**Re: Shepherds Lutheran
 3900 Wyoming Blvd NE
 Request Permanent C.O. - Accepted
 Engineer's Stamp dated: 1-2-14 (G20D036)
 Certification dated: 11-4-14**

RE: **Shepherd Lutheran Church – 3900 Wyoming Blvd. NE** File # **G20/D036**
Grading & Drainage Plan for Building Permit PE Stamp: 1/02/14

**RE: Grading and Drainage Plan
Shepards Lutheran Church (G20-D036)**

RE: **Shepherd Lutheran Church – 3900 Wyoming Blvd. NE** File # **G20/D036**
Grading & Drainage Plan for Building Permit PE Stamp: 11/01/13

SHEPHERD LUTHERAN CHURCH 3900 WYOMING BOULEVARD GRADING AND DRAINAGE PLAN		DRAWN BY WCHW DATE 02-13
			JOB # 21325

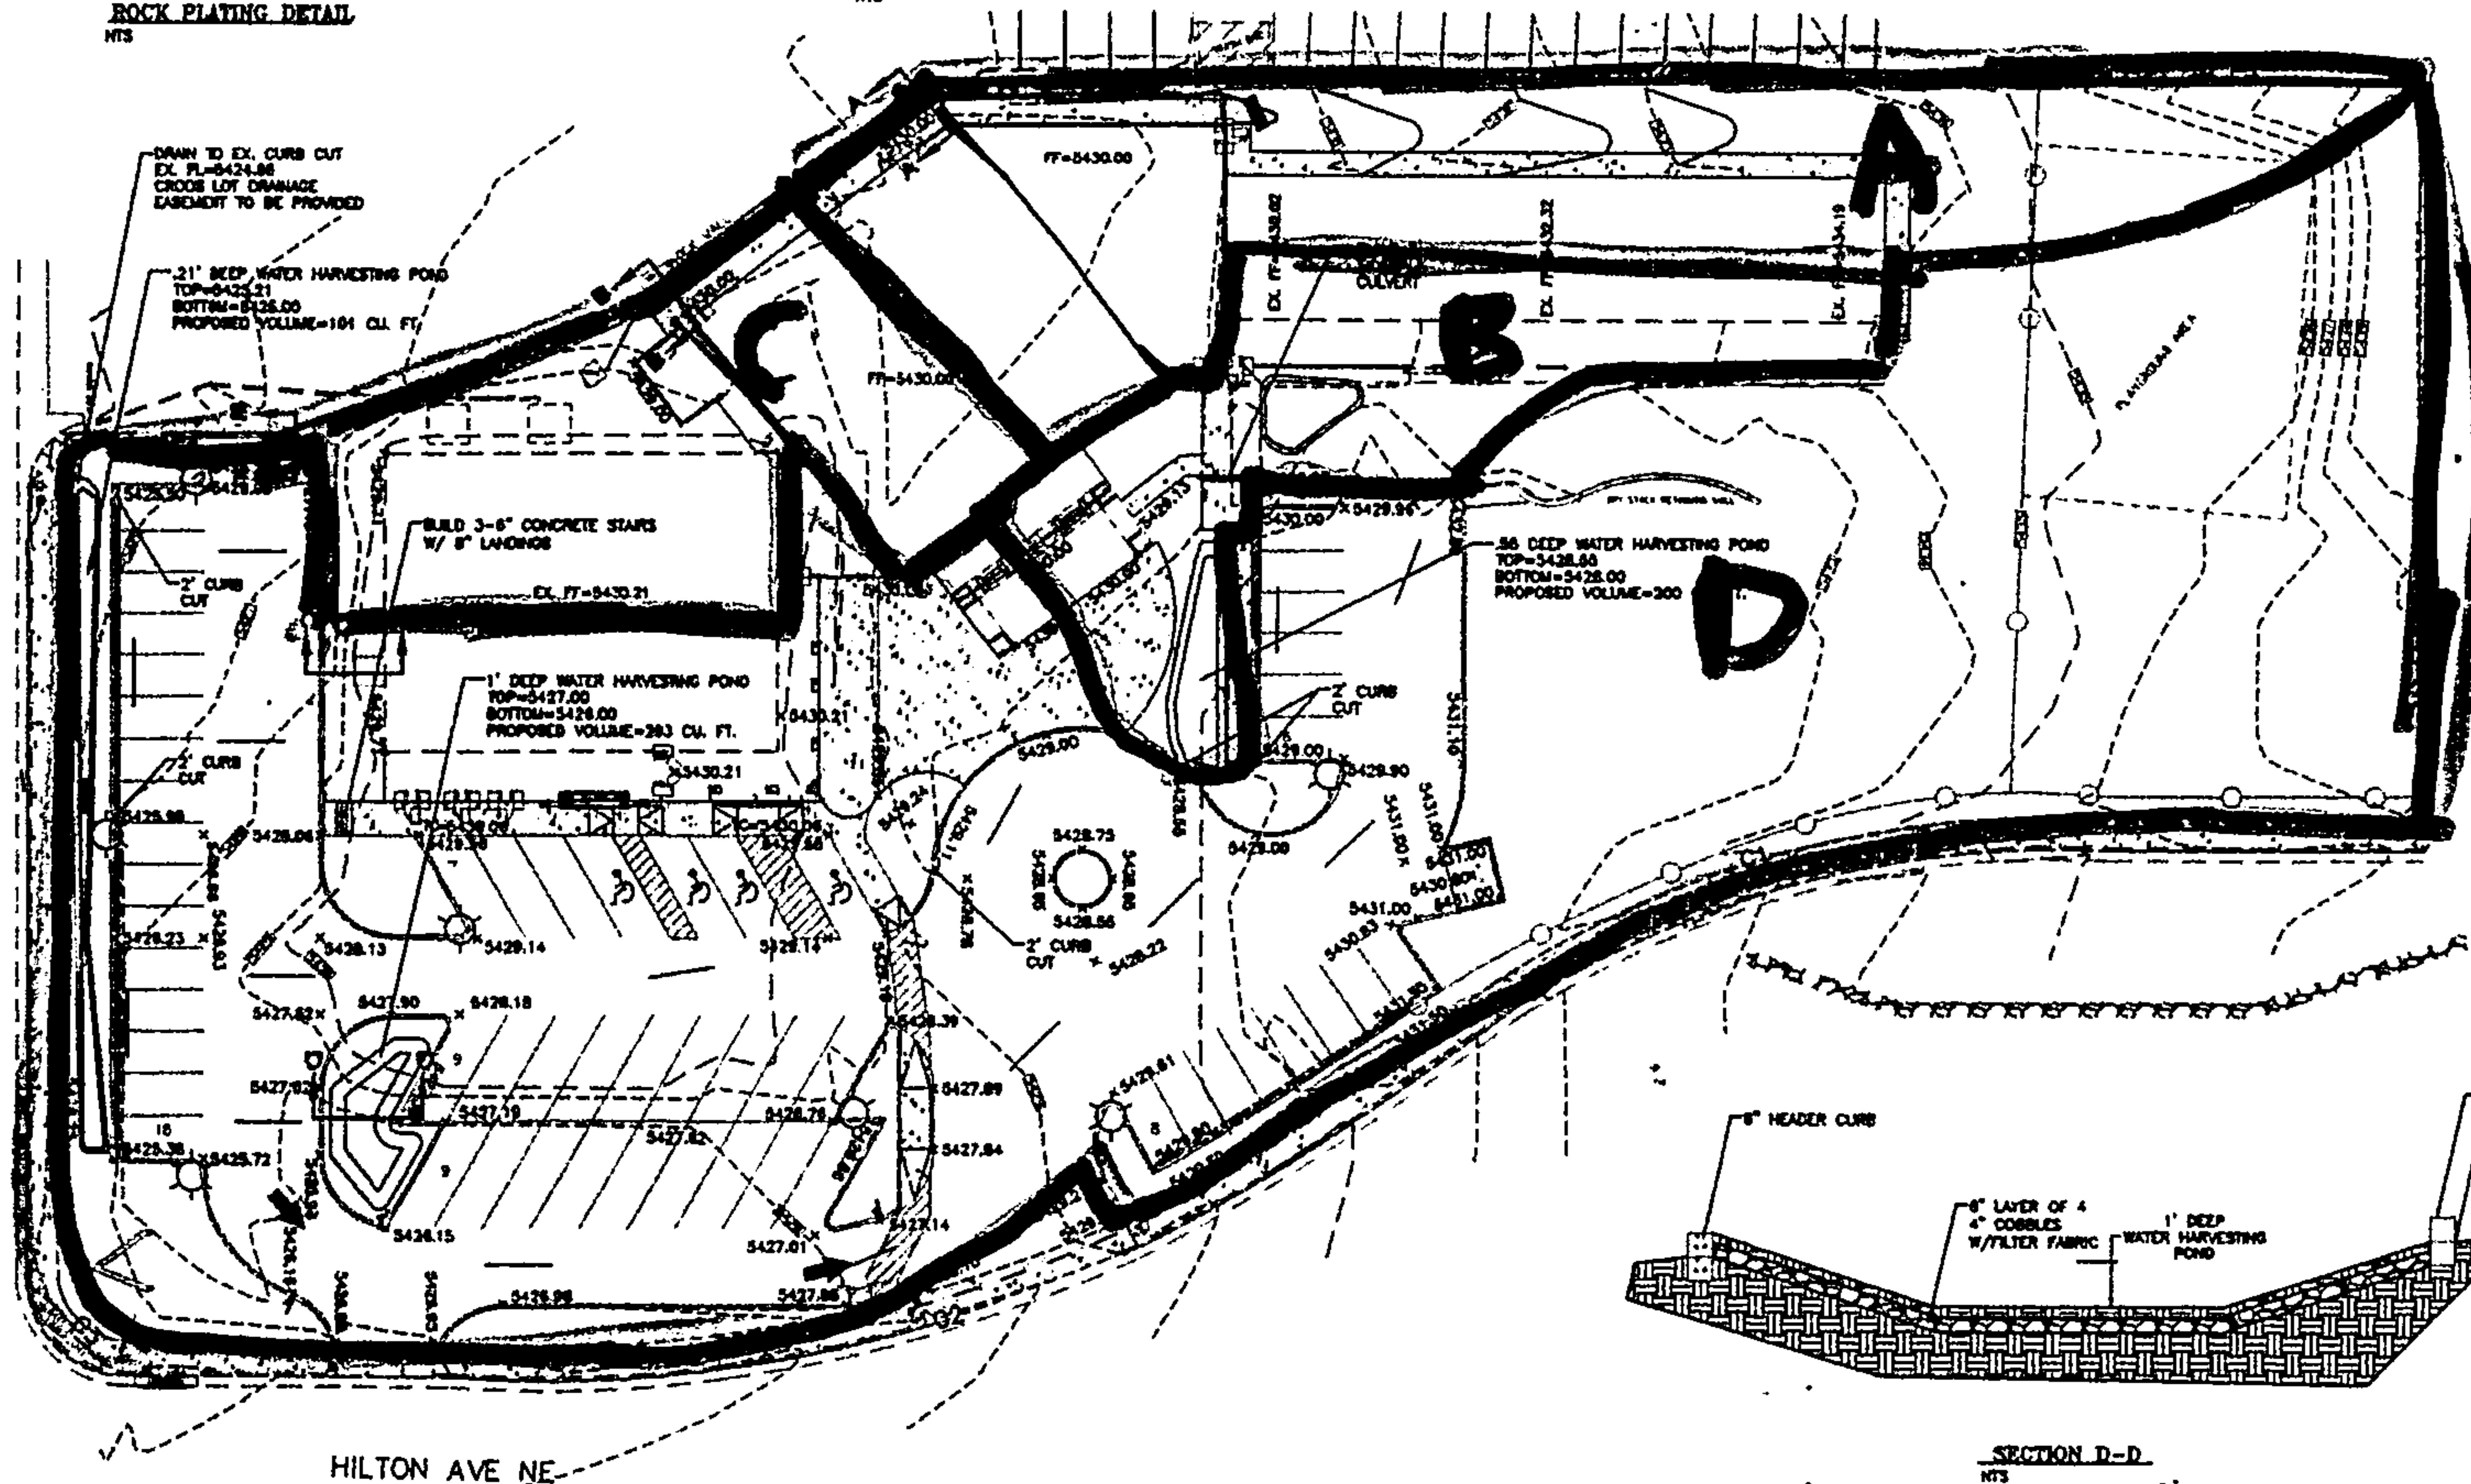
1. Show property boundaries and easements on the Grading Plan.
 2. Provide existing grades on the adjacent streets, particularly at driveways to Hilton and near the curb cut discharge point at the NW corner of the site.
 3. Historic drainage patterns routed approximately 25% of site flows out the westerly driveway, to an inlet on Hilton Place. This proposed plan diverts all of the flow to the NW corner of the site and expands a 2' curb cut to 9-feet wide. This amount of discharge to that driveway opening is not acceptable. Options to consider include:
 - a. Divert some of the site flow to the inlets on Hilton.
 - b. Provide a direct connection to the back of the inlet on Wyoming, via an SO-19, private storm drain connection.
 - c. Provide more defined grading to "Detention Ponds" on site to reduce the discharge rate.
- PO Box 1293
Albuquerque
New Mexico 87103
www.cabq.gov

4. Update the drainage basin map to include flow arrows and indicate discharge points. Inclusion of an existing basin map would be help to illustrate proposed changes.
5. Show the existing inlet location on Wyoming, and the second inlet on Hilton, between the driveways.
6. The Grading Plan does not include Proposed Contours for much of the site. Spot elevations provided do not clearly demonstrate intended flow patterns, and some such as the eastern parking area appear incorrect.

7. Clarify grades around parking areas; e.g.-sidewalk grades vs. pavement grades. Provide flow arrows and Proposed Contours to clarify flow patterns.
8. Grades provided do not clearly show how runoff will be directed to the Harvesting Pond in the southern parking area. Most flows appear to bypass the curb cut.
9. Flat grades around the Dumpster Pad with 0.2' depression at center will not drain.
10. Provide more detail of the pond along Wyoming. It appears from information provided that runoff will sheet flow over the sidewalk or wheelchair ramp, instead of discharging to the curb cut at the north end. Consider a Private Storm Drain connection to the inlet, per note 3.b above.
11. The plan shows a pipe on the north side of the existing building, with no size or slope information. Confirm capacity for the proposed flows between the existing garden wall and AC units.

1. Show property boundaries and easements on grading plan
We have shown better the property boundary and adjacent easement. The easement has not been filed so a copy of original is enclosed

2. Provide existing grades on adjacent streets and properties
We have added additional spots.
3. A. Divert some flow to Hilton
We have adjusted the plan to discharge approximately half of the discharge out to Hilton, to match existing conditions. The flows that leave the site are intercepted by the inlet on Hilton.

B. Provide direct connection to inlet at Wyoming with SO19
We have reduced the flow to less than 4 cfs. This flow can safely pass thru a 4" channel to the 15x15 easement on the adjacent property.

C. provide more defined grading to ponds
We have added more spots to better show water harvesting ponds.
4. Update drainage basin map:
We have enclosed updated drainage basin map

5. Show existing inlets
We have shown the existing inlets
6. Add proposed contours
We have added the proposed contours
7. Clarify grades around parking areas, i.e. sidewalks vs. pavement grades
All grades shown are flow line unless otherwise specified

8. Demonstrate the harvest ponds accept water
We have added more spots to better show water harvesting ponds.

9. You do not have sump in dumpster
We have removed the sump.

10. provide detail for pond on Wyoming,
We have added more contouring in pond

SECTION D-D
NTS

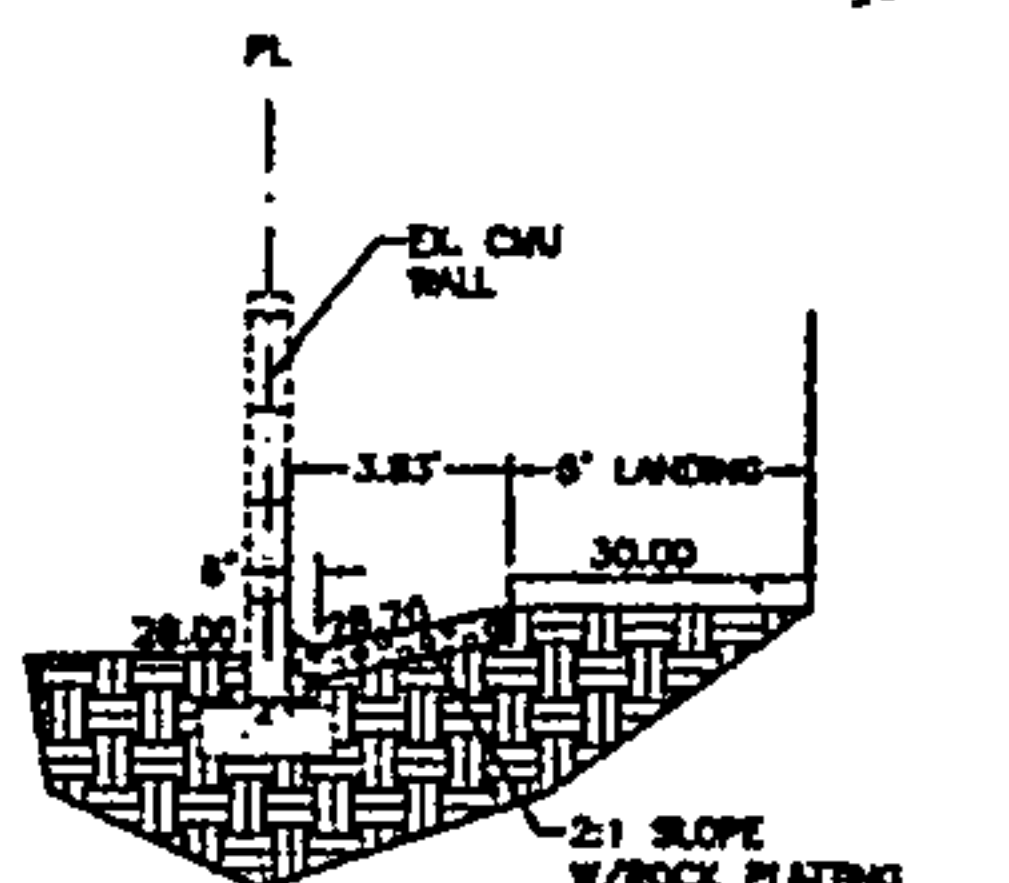
PO Box 1293
Albuquerque
It is acknowledged that the upper layer of material that is shown in Section D-D of the plan (unlabelled) is a drafting error, and is to be disregarded.
